**Foreløbig redegørelse
i anledning af havarier
med Dash-8 Q400
9. og 12. september 2007**

Bilag til redegørelsens kap. 6

1 TITLE Inspection procedure for retraction actuators p/n 46550-7 or 46550-9 rod end.			2 RD NUMBER 8/4-32-059	
			3 SECTION 1	4 SHEET 1
5 PRIME DESIGN ACTIVITY BOMBARDIER INC., DOWNSVIEW 71867	6 ADDITIONAL LIMITATIONS NONE	7 SERIES DHC-8-400	8 APPLICABILITY Models 400, 401 and 402

SERVICE CONCESSION REQUEST			SCR NUMBER	REV	PROG
					SCR 086-07	NC	2130
		AIRCRAFT DETAILS			INDICATE IF		
EVENT DATE (Y/M/D)	AIRLINE	A/C S/N	TSN	CSN	A.O.G. >> <input checked="" type="checkbox"/> <<		
ANY	ALL	4001 AND SUB					
ITEM	PART NO.	NAME			S/N	TSN	CSN
N.H.A ⇌							
N.H.A ⇌	46550-71-9	RETRACTION ACTUATOR			ALL		
PART ⇌	46570-11-3	PISTON			ALL

1 TITLE Inspection procedure for retraction actuators p/n 46550-7 or 46550-9 rod end.			2 RD NUMBER 8/4-32-059	
			3 SECTION 1	4 SHEET 1
5 PRIME DESIGN ACTIVITY BOMBARDIER INC., DOWNSVIEW 71867	6 ADDITIONAL LIMITATIONS NONE	7 SERIES DHC-8-400	8 APPLICABILITY Models 400, 401 and 402

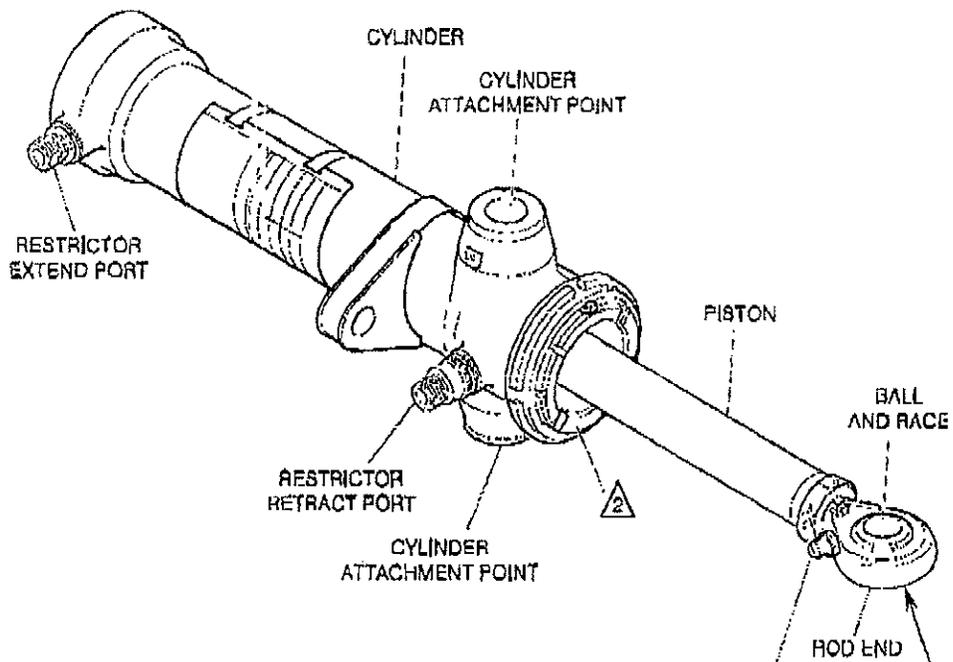
AT ISS. 2: SCR REF CHANGED TO REV. A, WAS REV. NC

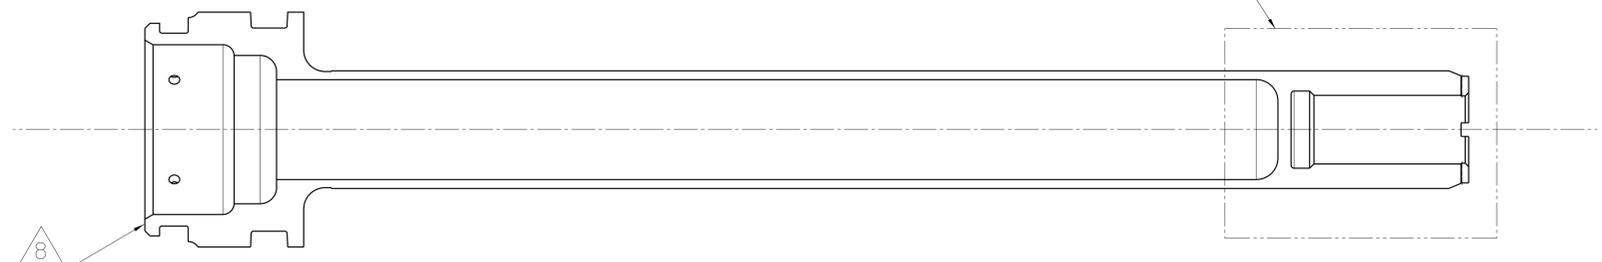
No corrosion or wear damage is allowed, EXCEPT AS NOTED IN SCR 086-07 REV. A B
 Provided the components are free of any damage re-assemble retraction actuator in accordance with SCR 086-07 rev. ~~RE A~~ B

FIGURE 1

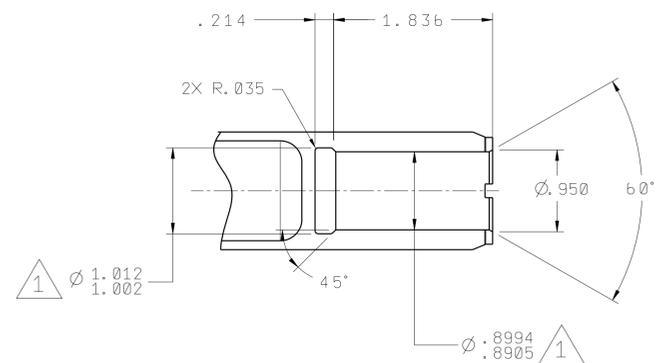
1. MACHINE DISCREPANT THREAD AND OPEN BORE TO REMOVE ALL DAMAGE, CORROSION ETC, AS SHOWN ON FIGURE 1. DO NOT EXCEED MAX REWORK SPAN AS SHOWN.
2. INSPECT REWORK DIAMETER TO ENSURE ALL DAMAGE AND CORROSION ARE REMOVED.

SEE FIGURES 1, 2 AND 3 FOR BORE RPREPARATION AND HELICAL COIL INSTALLATION

FIGURE 2

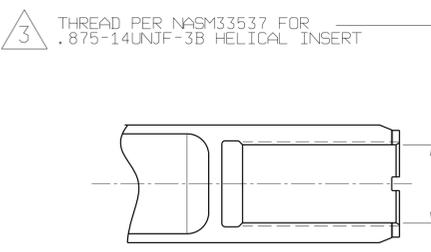
3. MACHINE THREAD AS SHOWN ON FIGURE 2, PER NASM33537, FOR STANDARD HELICOIL INSERT .875-14UNJF-3B, P/N MS124704 PER NASM124704.
4. DEBURR AND BREAK ALL SHARP EDGES AT REWORKED AREA.

FIGURE 3

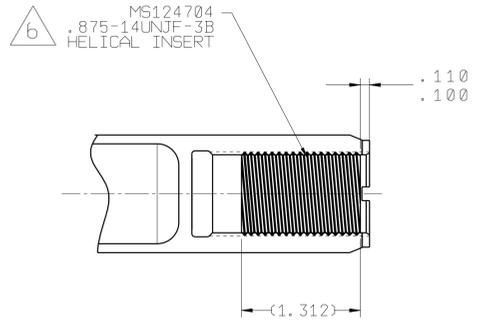
5. MAGNETIC PARTICLE INSPECT REWORKED AREA PER ASTM E1444. DEFECTS NOT TO EXCEED MIL-STD-1907 GRADE "A" LIMITS.
6. PRIOR TO ASSEMBLY, LIBERALLY APPLY CIC MASTINOX 6856K OR CORBAN 27L ALL OVER THREADS/MATING SURFACES, INSTALL HELICAL COIL INSERT .875-14UNJF-3B P/N MS124704 AS SHOWN ON FIGURE 3. INSTALL PER NASM33537. ENSURE TANG IS REMOVED AFTER INSTALLATION.

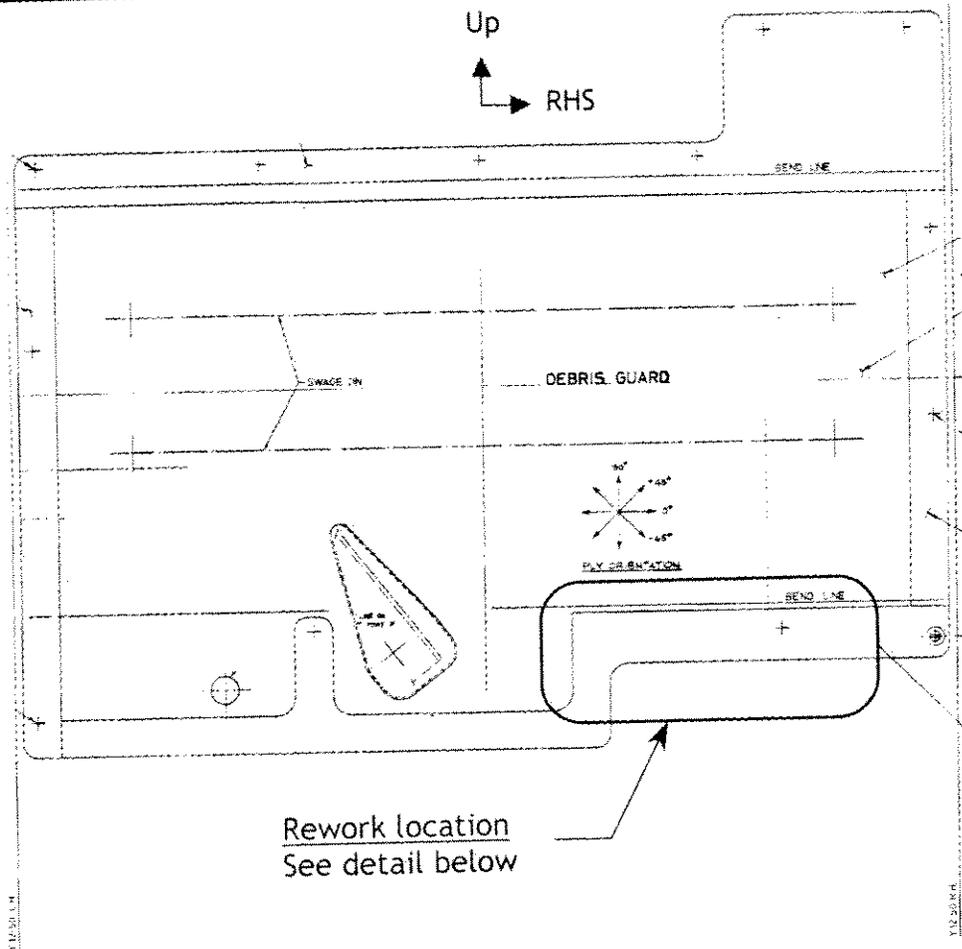
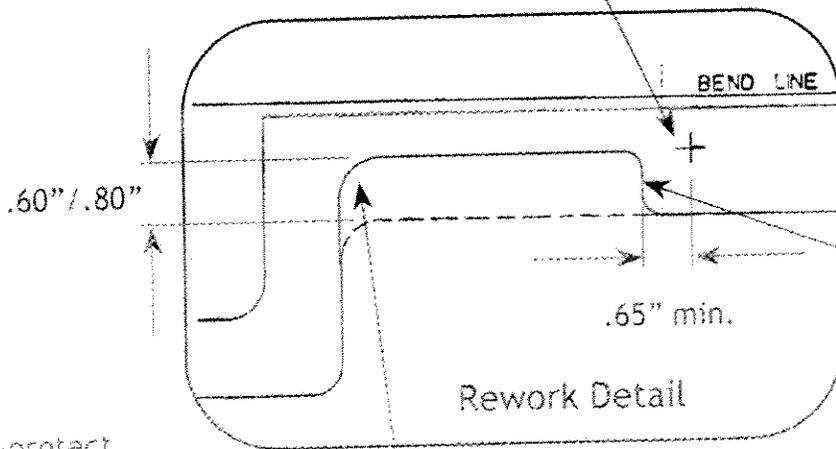
1. Re-profile the lower edge of the nose landing gear door mechanism debris guard, P/N 83220012, as shown on Sheet 2.

Maintain maximum cutout dimensions and minimum distance to the adjacent Camloc as shown on Sheet 2. Ensure that all chafe damage is removed by the cutout.

Note: In lieu of the maximum cutout shown on Sheet 2 a smaller cutout may be used provided that the min. corner radii and distance from the Camloc is maintained and that all of the damage has been removed.

1 TITLE Inspection procedure for retraction actuators p/n 46550-7 or 46550-9 rod end.			2 RD NUMBER 8/4-32-059	
			3 SECTION 1	4 SHEET 1
5 PRIME DESIGN ACTIVITY BOMBARDIER INC., DOWNSVIEW 71867	6 ADDITIONAL LIMITATIONS NONE	7 SERIES DHC-8-400	8 APPLICABILITY Models 400, 401 and 402

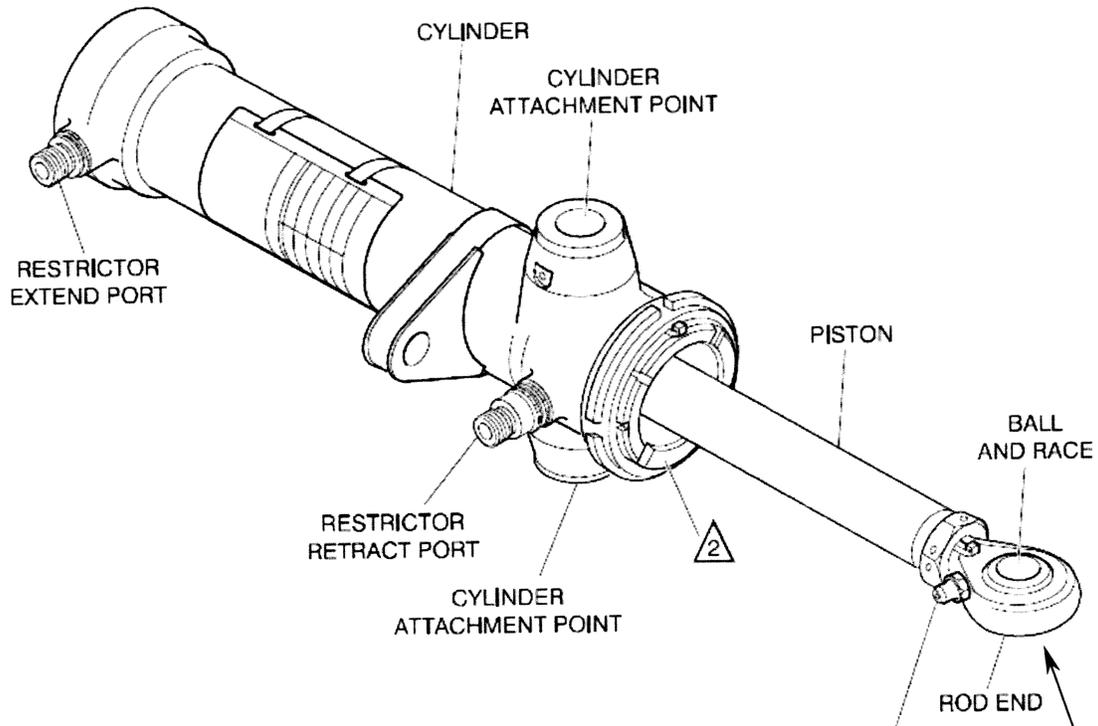
At SCR 086-07 Rev D: Rework for Freeze fit Pin in SCR now deleted-Ref. Dwg S2117-deleted. New Inspection criteria added for reworked Actuators (excluding those repaired by Section B) Page 1,2 raised to Issue # 5.

Retraction actuator assembly p/n 46550-7/-9

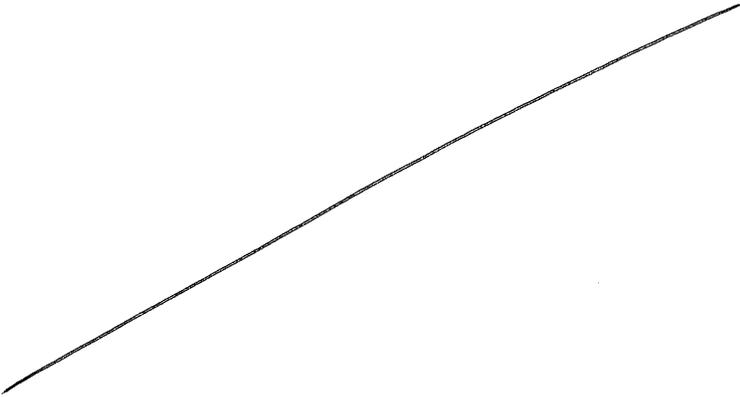
Remove the rod end of the retraction actuator assembly in accordance with SCR 091-07 rev. NC

Inspect cylinder P/N 4655-1 for evidence of corrosion on Gland Nut threads.

Inspect Gland Nut P/N 46572-5 for evidence of corrosion on threads.

1 TITLE Inspection procedure for retraction actuators p/n 46550-7 or 46550-9 rod end.			2 RD NUMBER 8/4-32-059	
			3 SECTION 1	4 SHEET 1
5 PRIME DESIGN ACTIVITY BOMBARDIER INC., DOWNSVIEW 71867	6 ADDITIONAL LIMITATIONS NONE	7 SERIES DHC-8-400	8 APPLICABILITY Models 400, 401 and 402

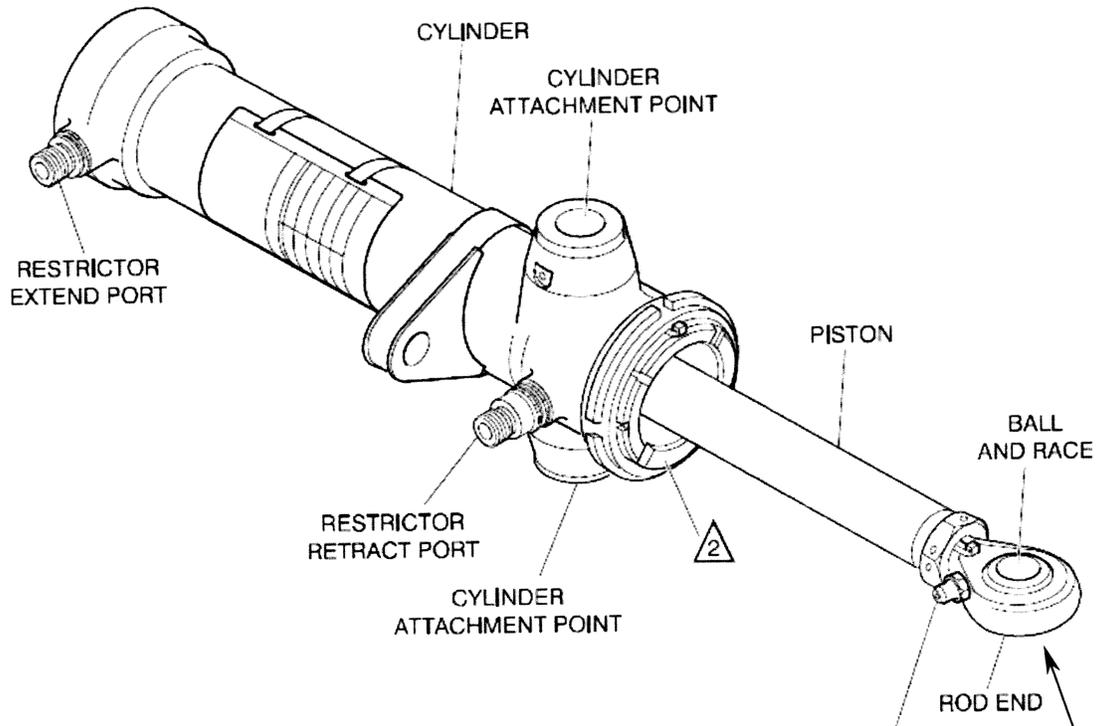
At SCR 086-07 Rev D: Rework for Freeze fit Pin in SCR now deleted-Ref. Dwg S2117-deleted. New Inspection criteria added for reworked Actuators (excluding those repaired by Section B) Page 1,2 raised to Issue # 5.
